Feb 3 1990

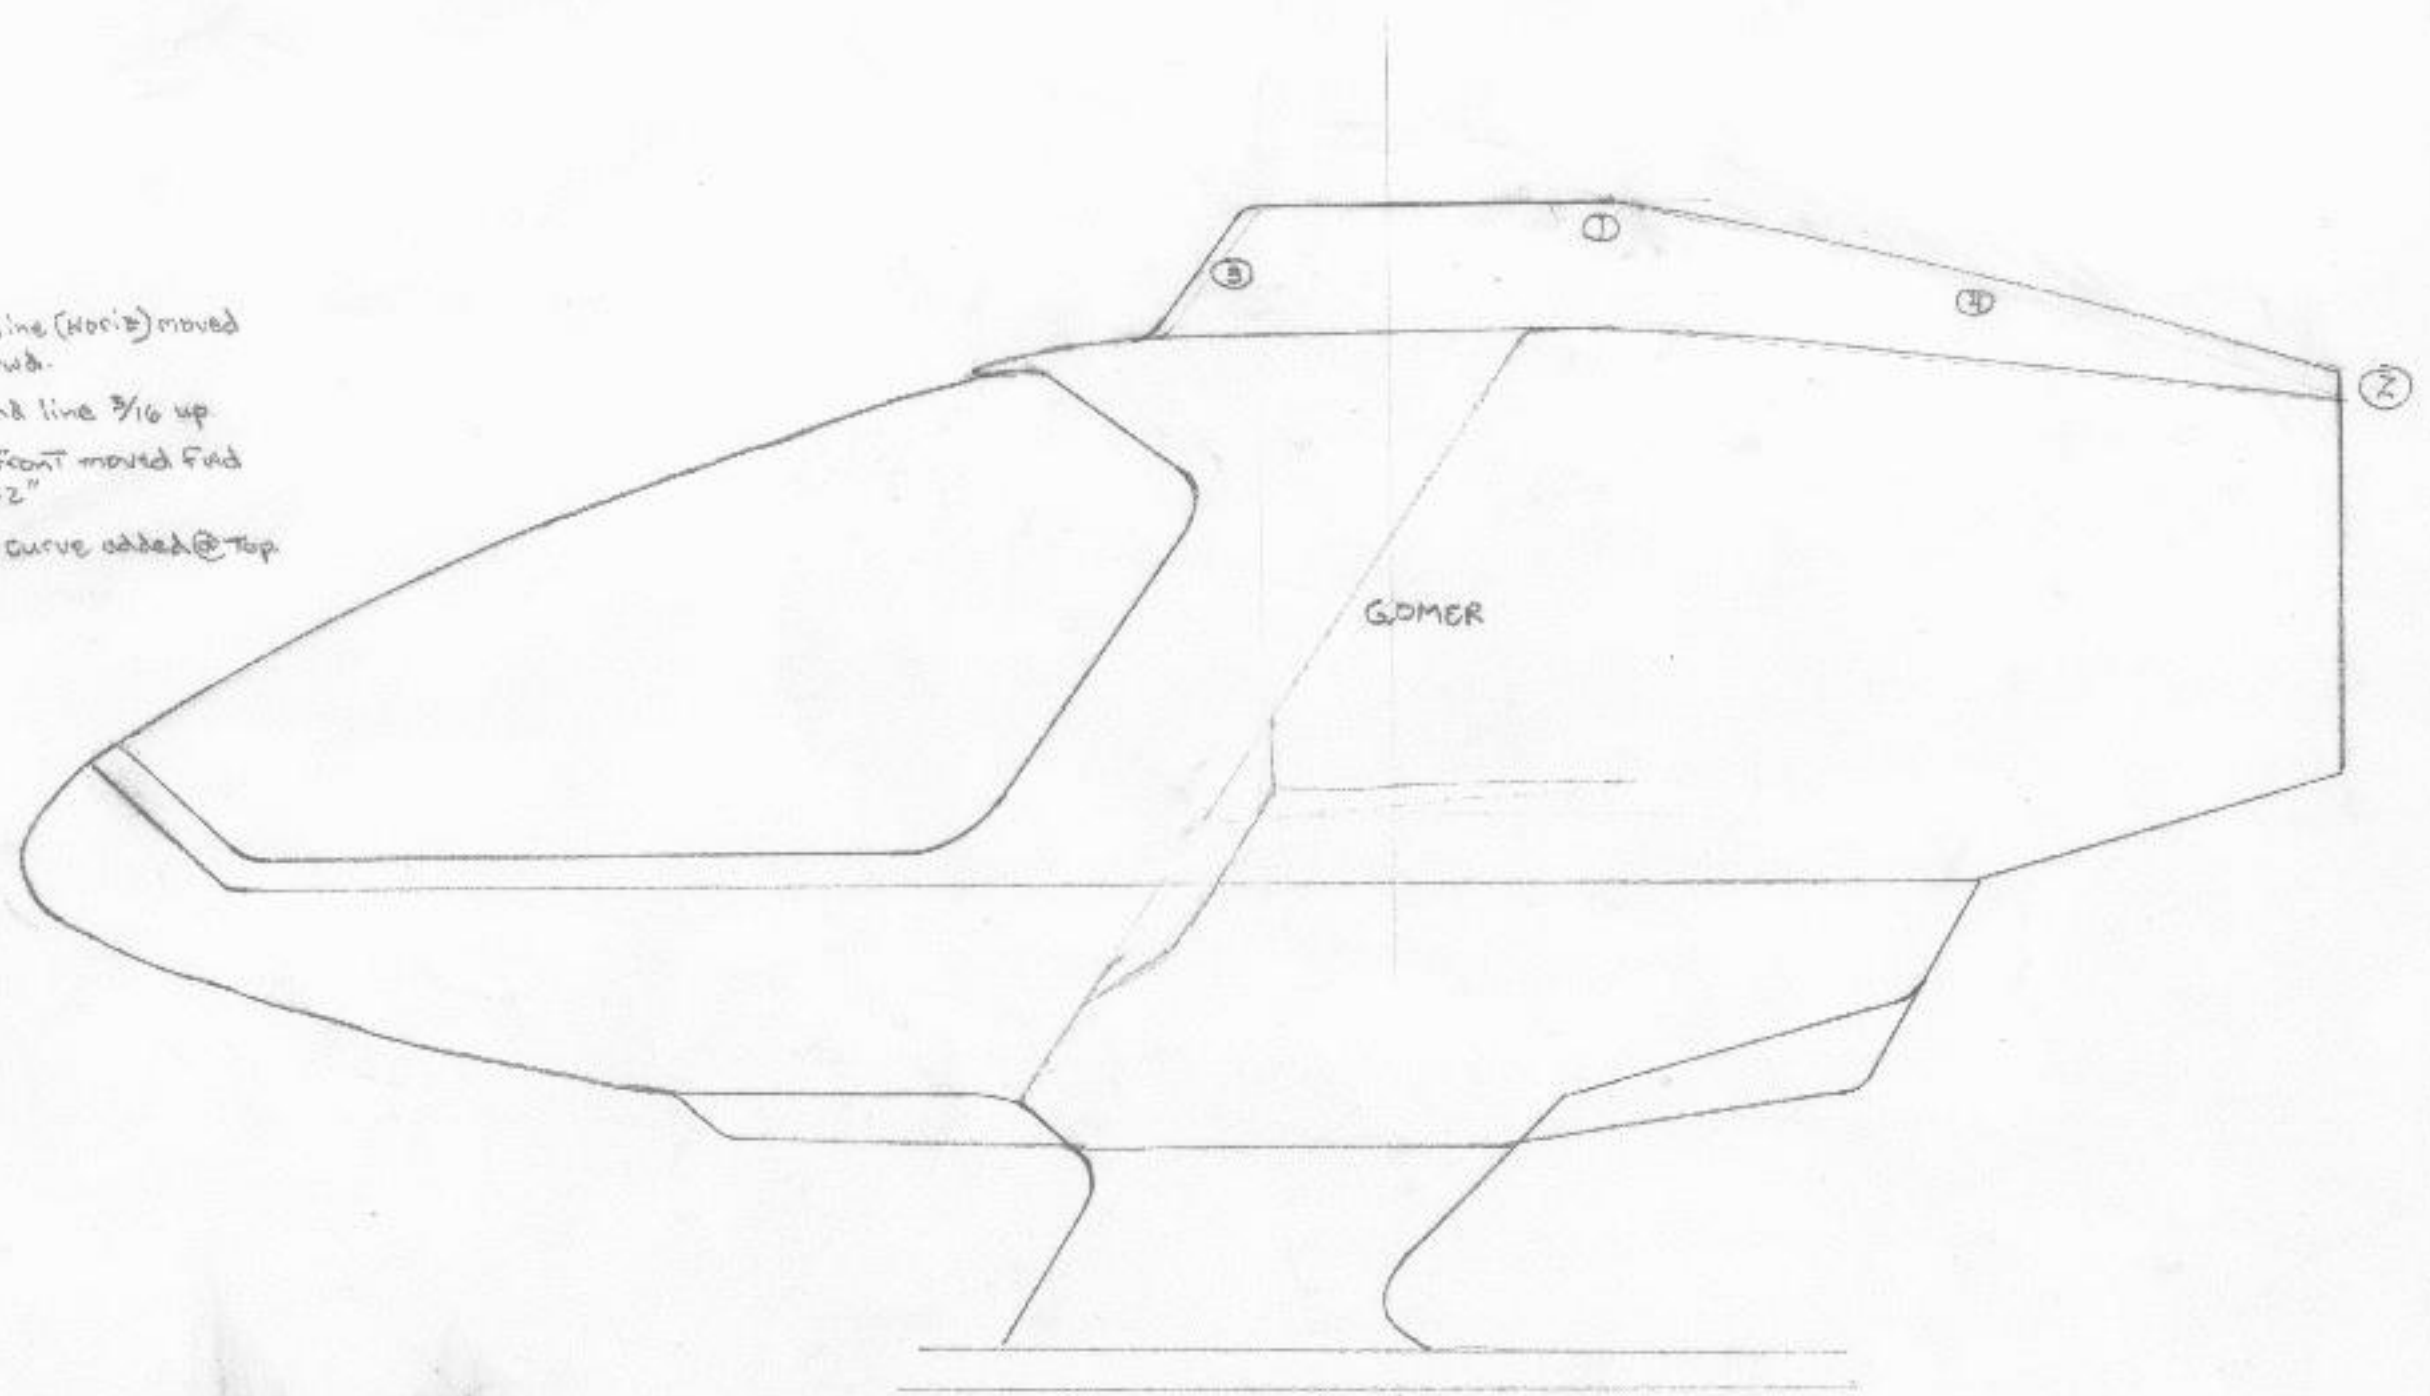
- ① Taper line (Horiz) moved $\frac{3}{4}$ " fwd.
- ② Vert. end line $\frac{3}{16}$ " up
- ③ Rotor front moved fwd by $\frac{3}{8}$ "
- ④ Gentle curve added @ top

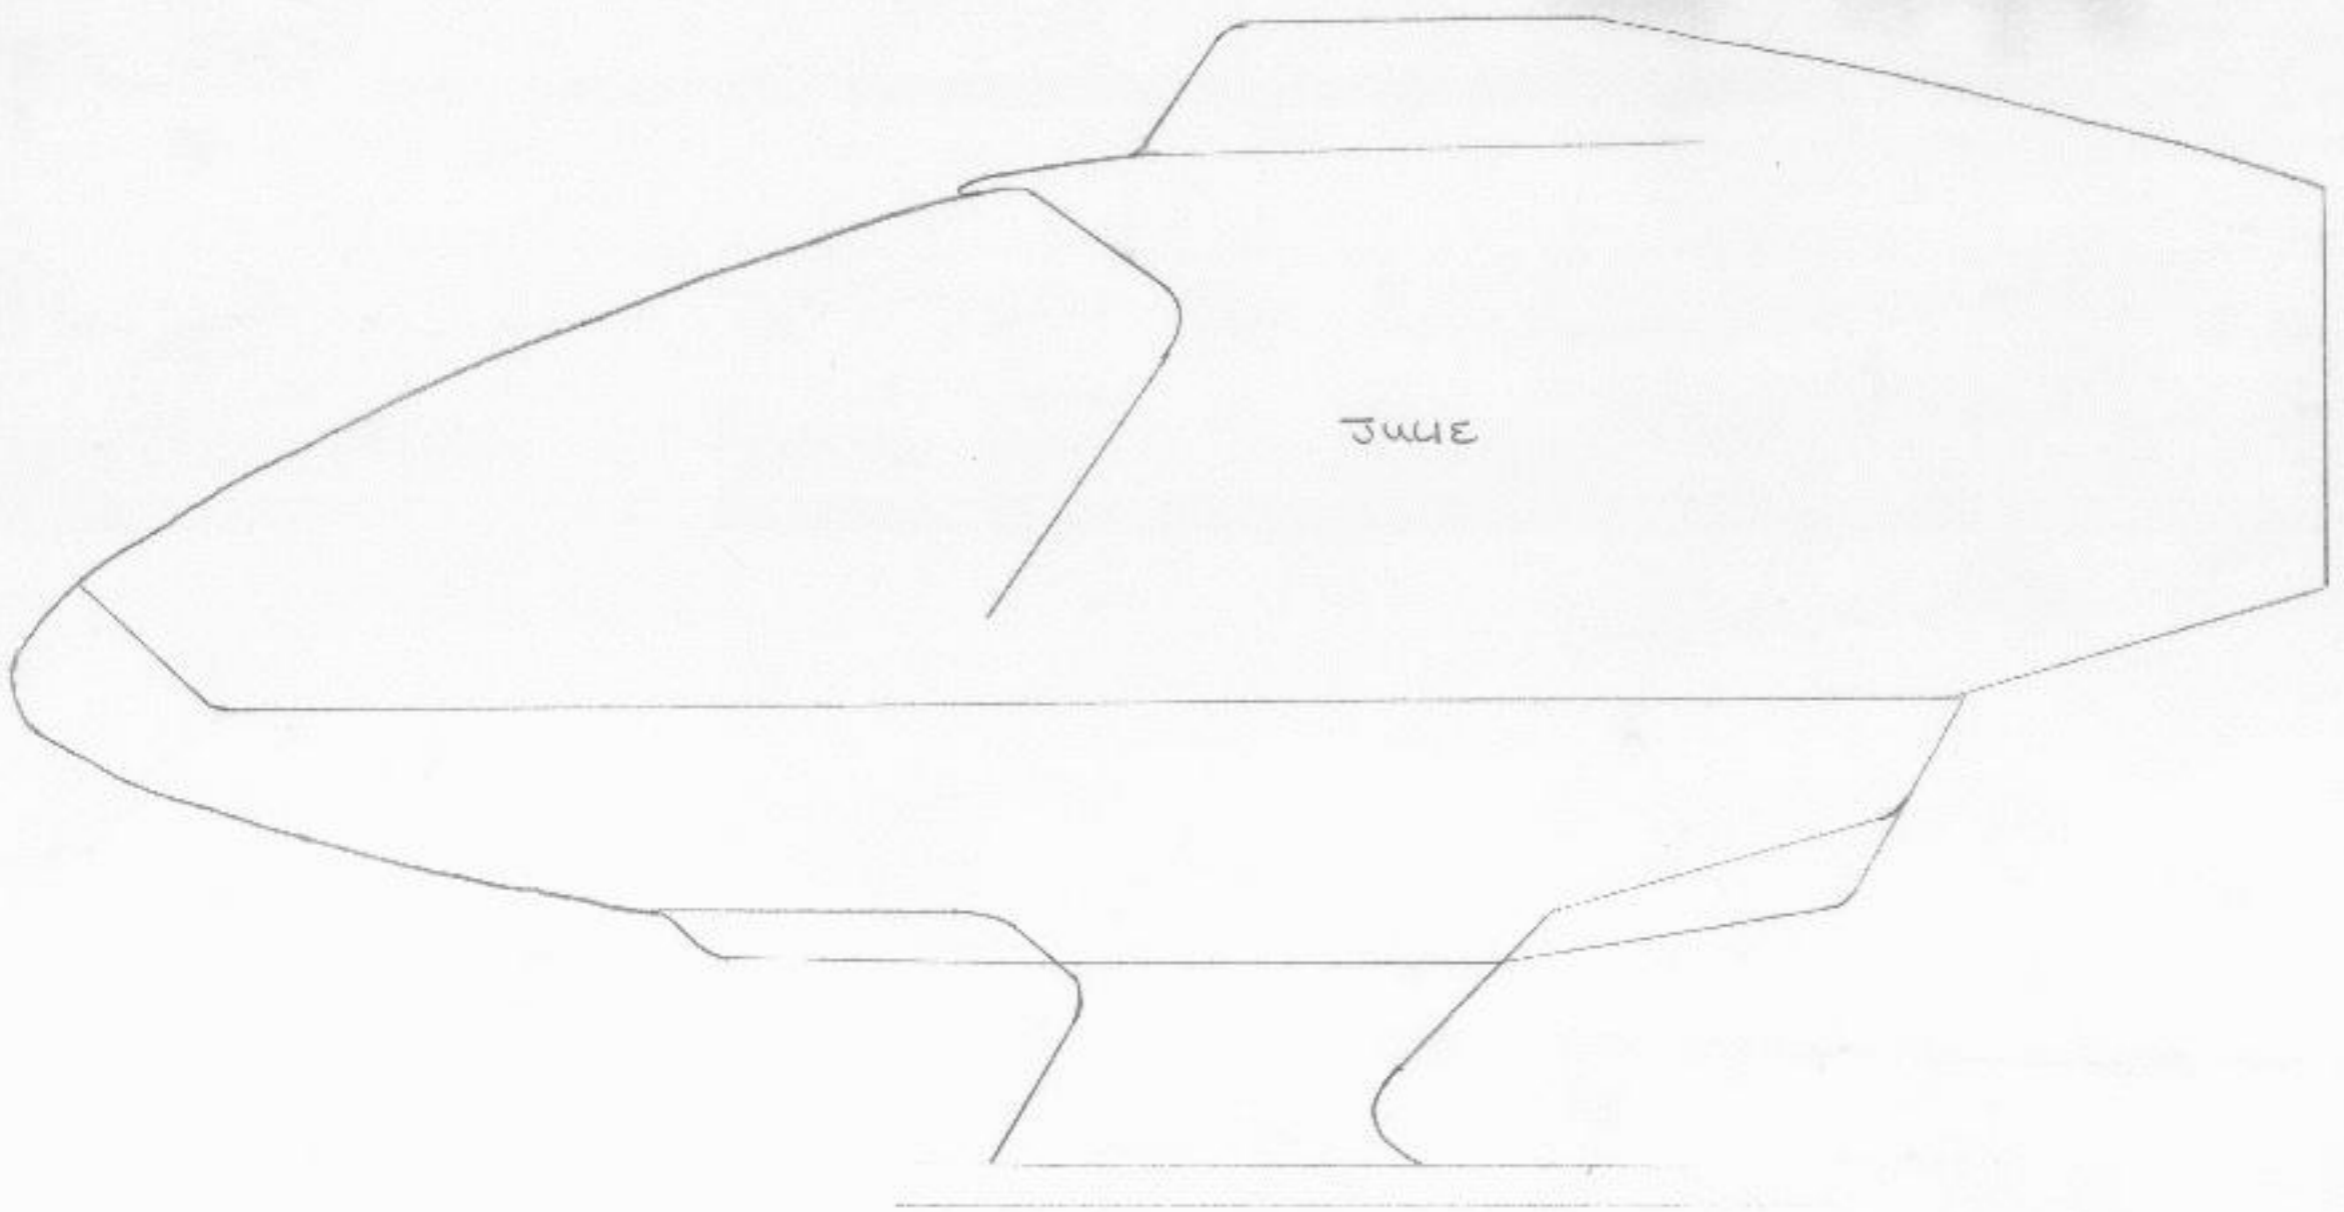
- ✓ 1. LG vert + horiz position of recess
- 2. Windshield line at glass joint
- 3. Windshield outline either pos. + neg.
- 4. Frame line vs canopy line at top outline
- 5. Engine/Ni-Startier hollow

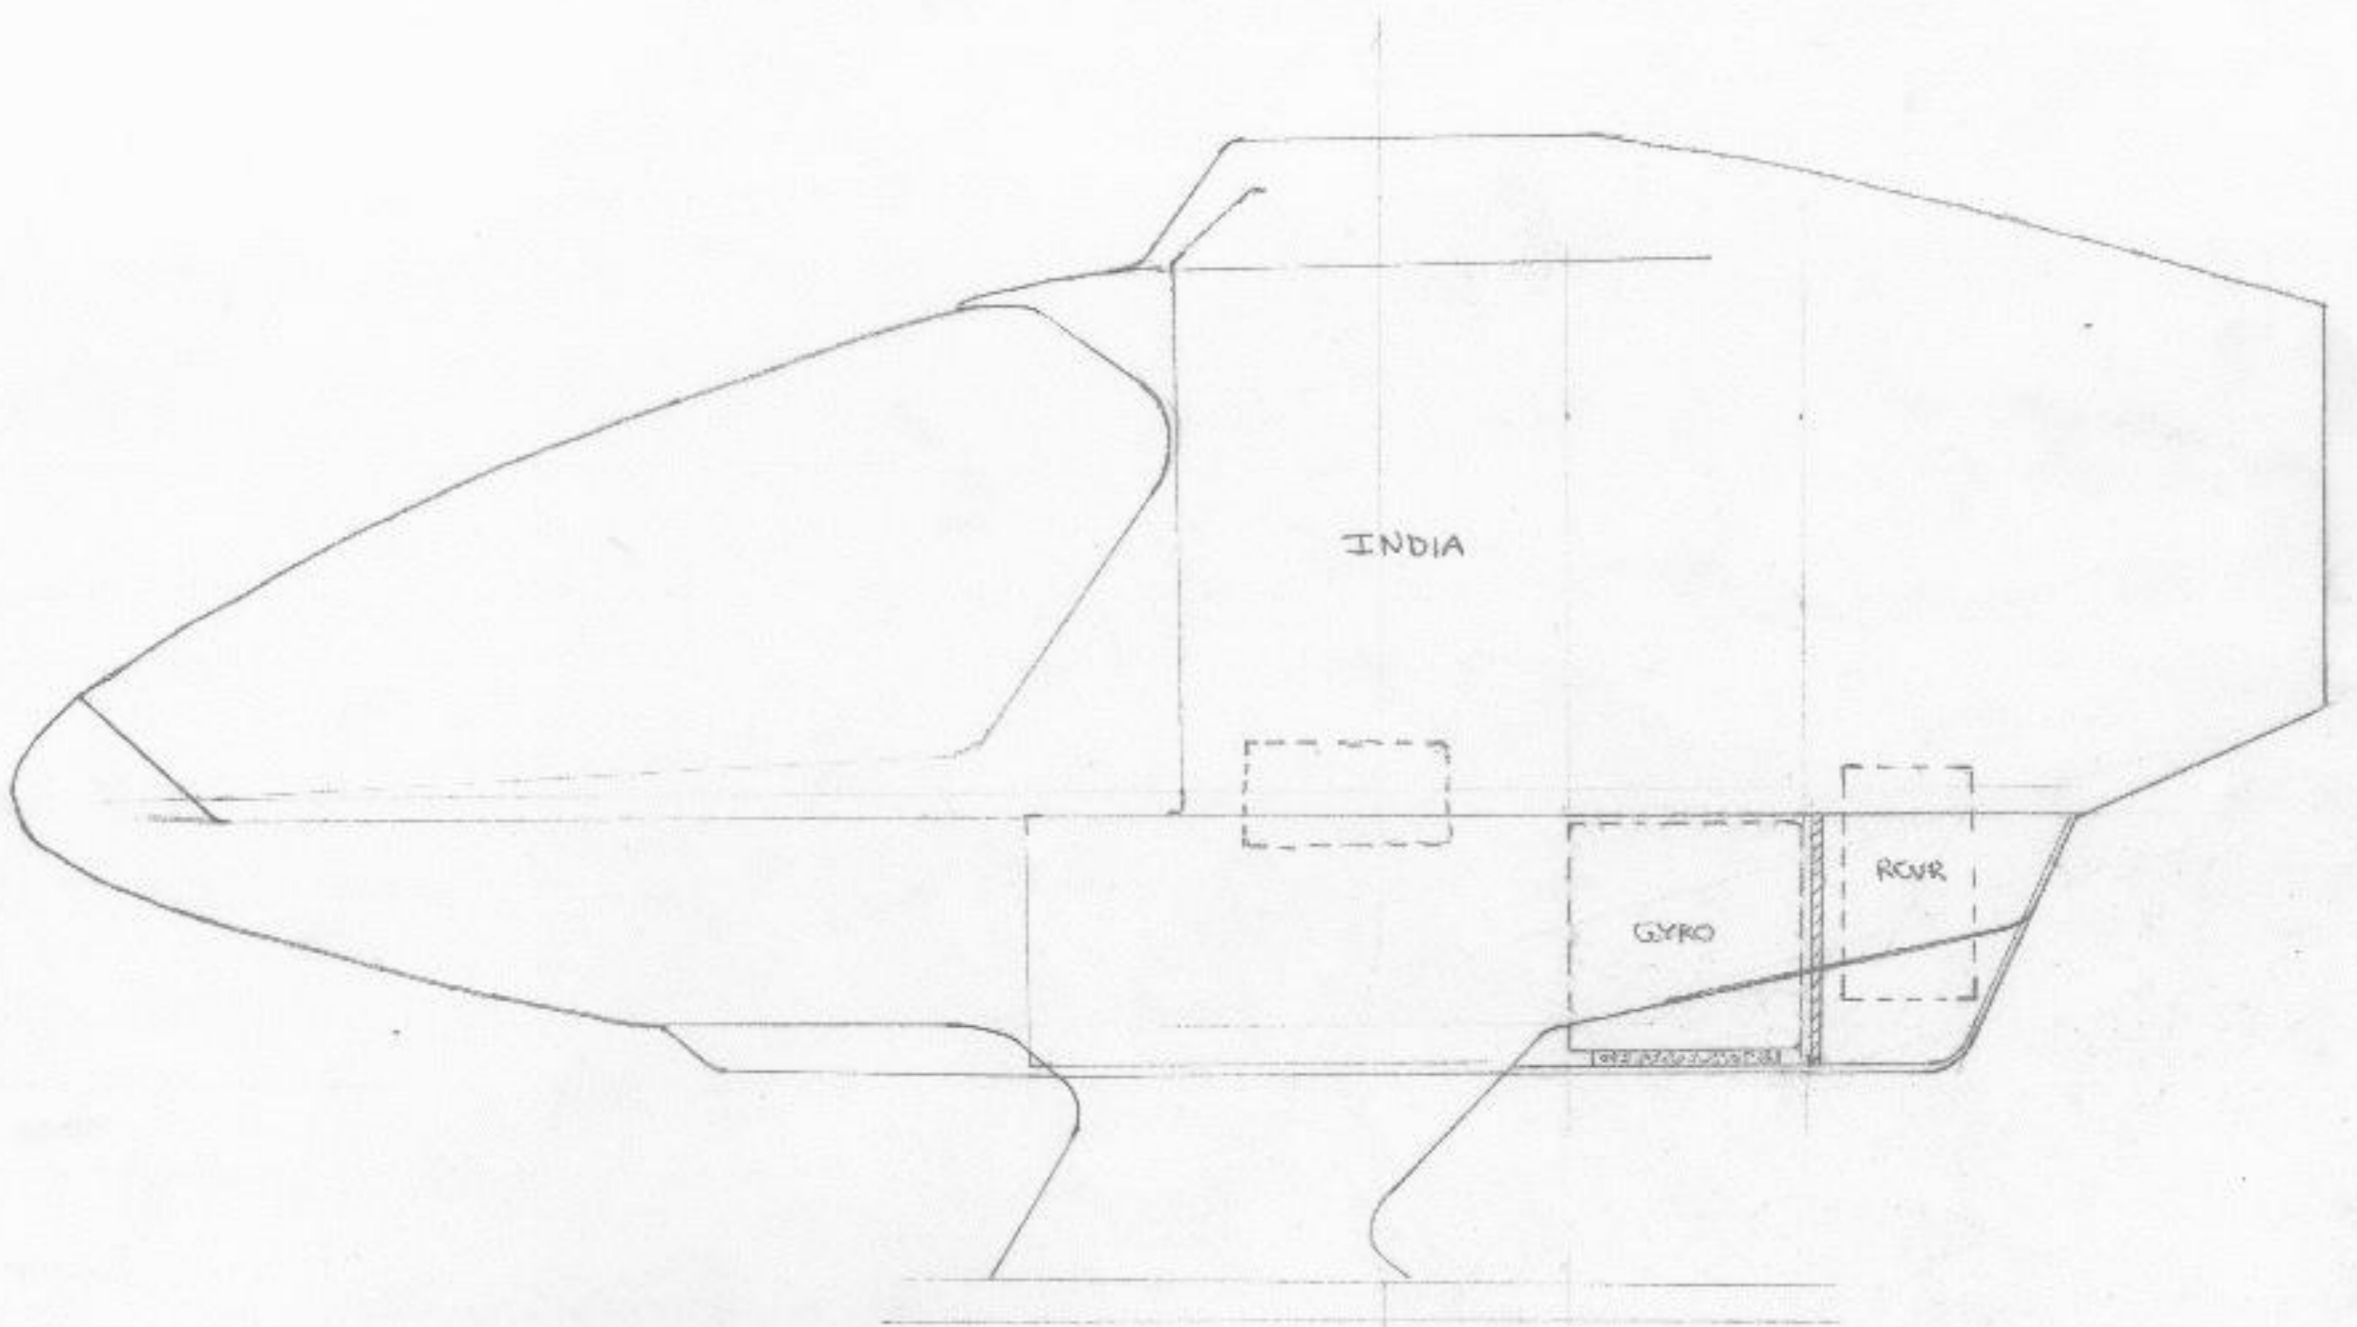
① Neg windshield!
